Memorandum Department of Planning & Public Works

RE: P.Z. 47-2007 Conway Point Office Building (Conway Partners, LLC): A request for an ordinance amendment to amend the legal description, permitted uses, and development criteria for the 1.063 acre parcel of land, zoned "PC" Planned Commercial District, located at 15310 Conway Road, at the southeast corner of the intersection of Chesterfield Parkway and Conway Road.

RE: **P.Z. 47-2007 Conway Point Office Building (Conway Partners, LLC);
Revised Plan Eliminating Drive-Through/Drive-Up Banking**

Preliminary Plan for
CONWAY POINT OFFICE BUILDING
 15310 Conway Road
 Chesterfield, Missouri 63017

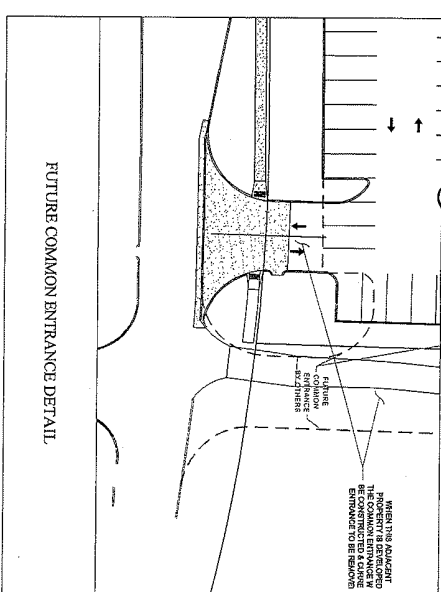
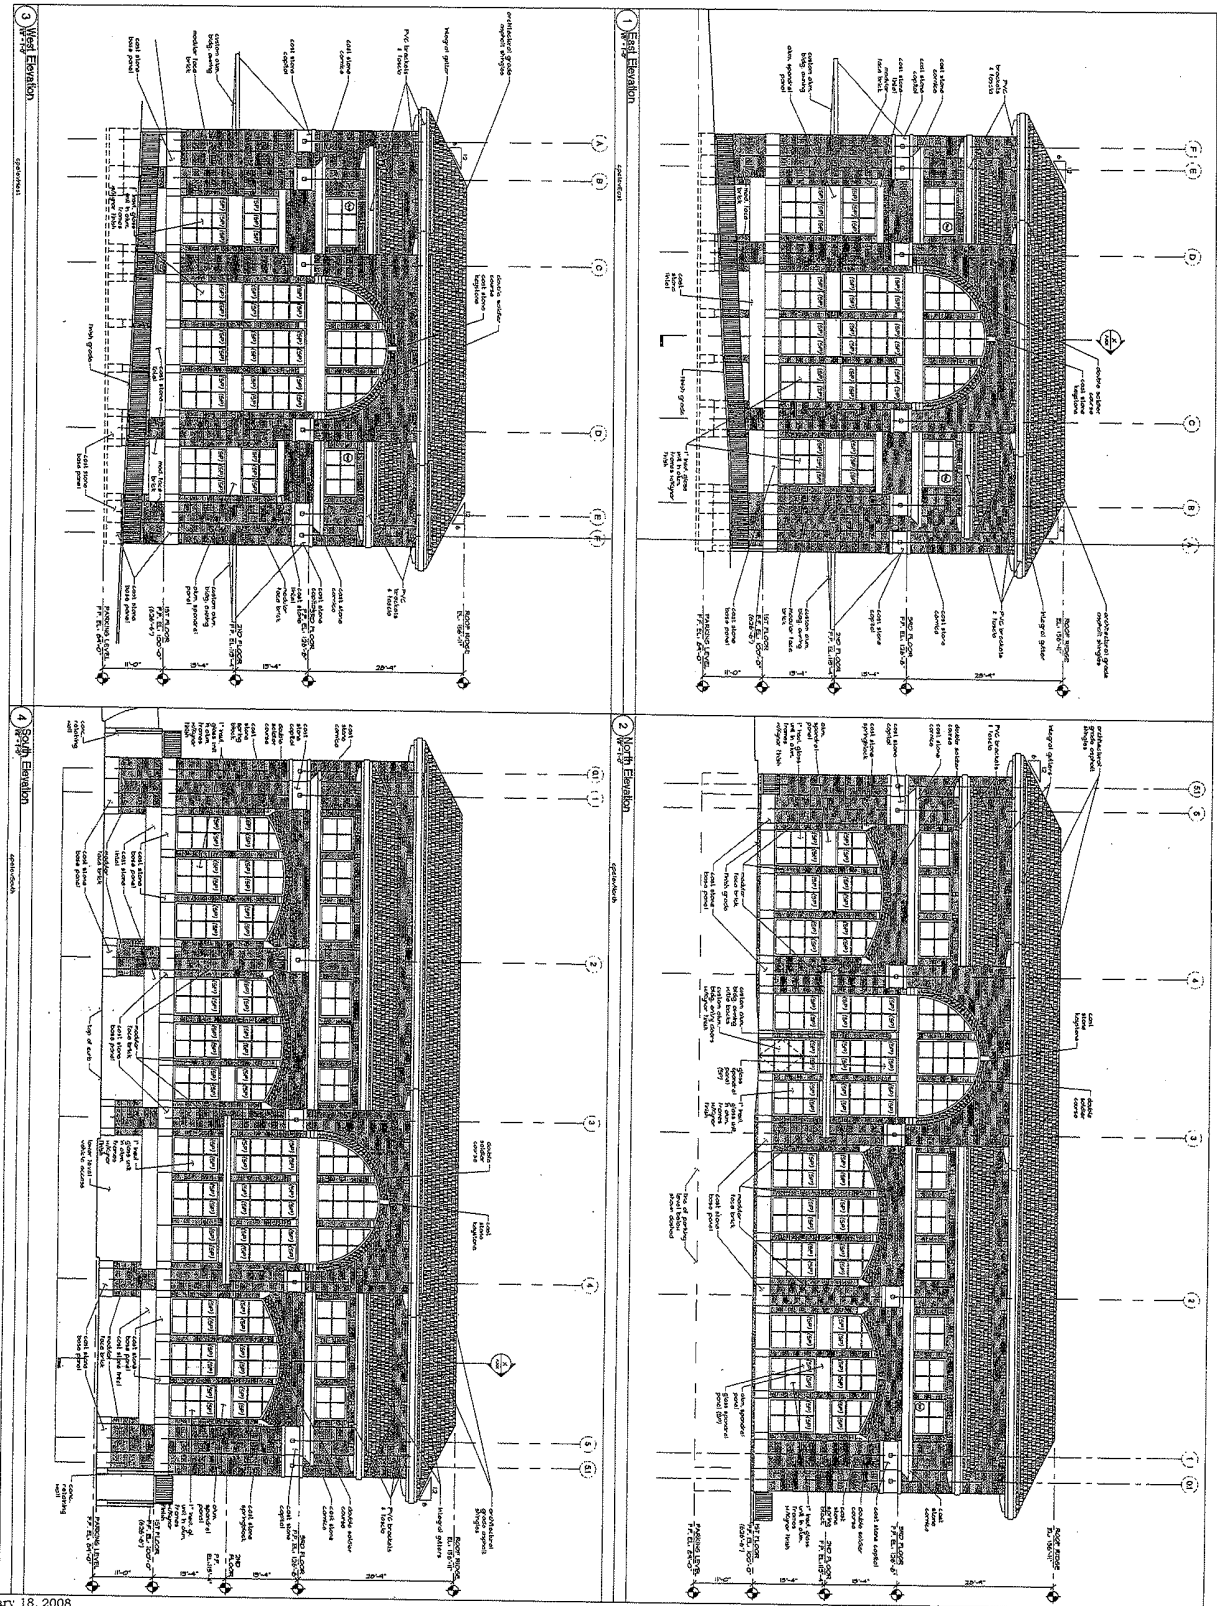
Nonetheless, in an effort to address City officials' concerns, Conway Partners has developed a revised plan for the Project (see attached). The revised plan eliminates all drive-through lanes for the Project, which has the practical effect of defeating any possibility that a retail bank could someday occupy the space at issue. The revised plan has the added benefit of increasing open space for the project to currently 38%. (Please note, including all area that Conway Partners is going to be legally obligated to landscape and maintain, the Project is currently at 48% open space. Conway Partners remains amenable to ordinance language which states that a reduction in open space is being granted based on Conway Partners legally binding agreements to maintain certain adjacent green space).
